Amendments to the Drawings:

Appl. No. 09/990,976
Pre. Amdt. dated Dec. 4, 2003
REPLACEMENT SHEET

FIG. 1

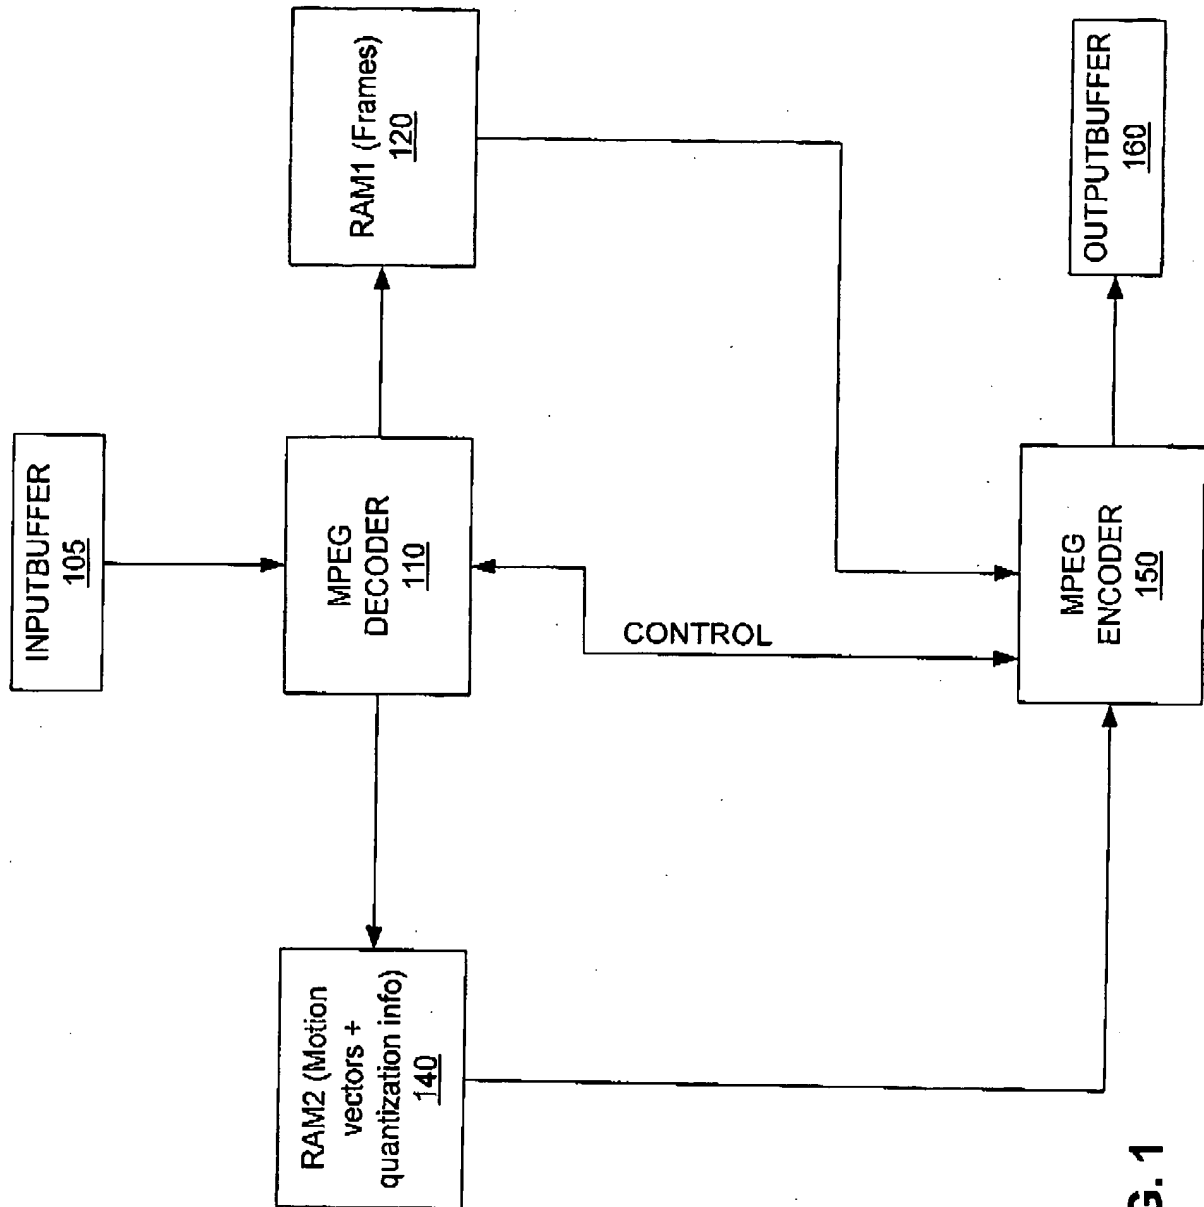
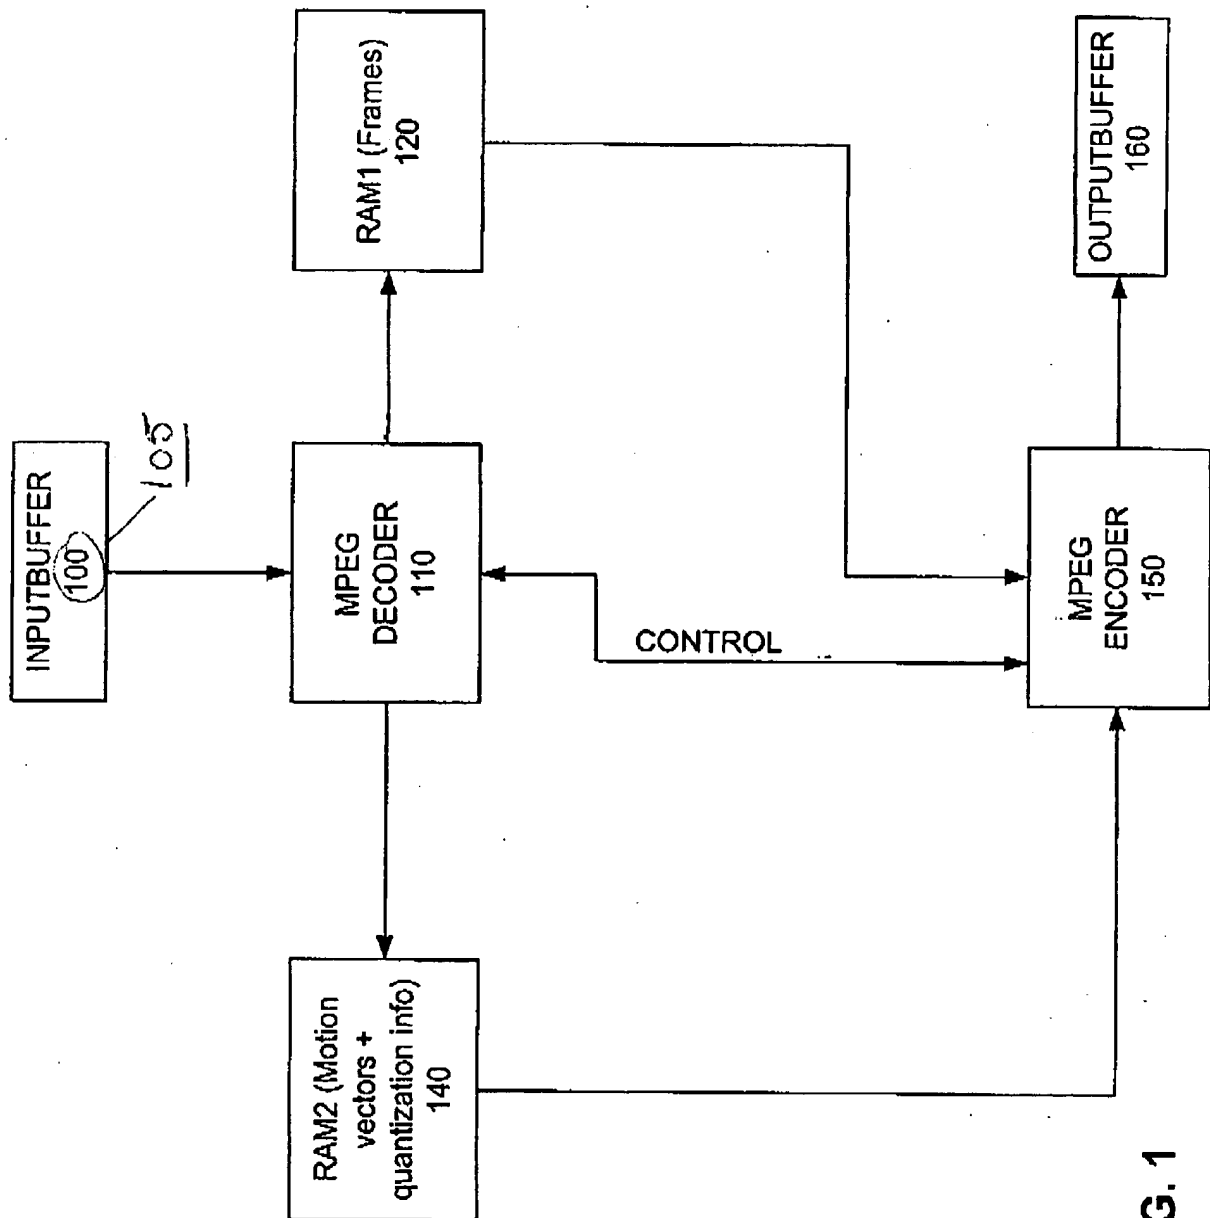
The attached sheets of drawings includes changes to FIGS. 1 and 8. These sheets, which include FIGS. 1 and 8, replace the original sheets including FIGS. 1 and 8. In FIG. 1, the INPUTBUFFER 100 has been corrected to read INPUTBUFFER 105, as shown on page 5, line 26 of the Specification. In FIG. 8, ELEMENTARY STREAM DATA 712 has been corrected to read ELEMENTARY STREAM DATA 391, as shown on page 20, line 24 of the Specification.
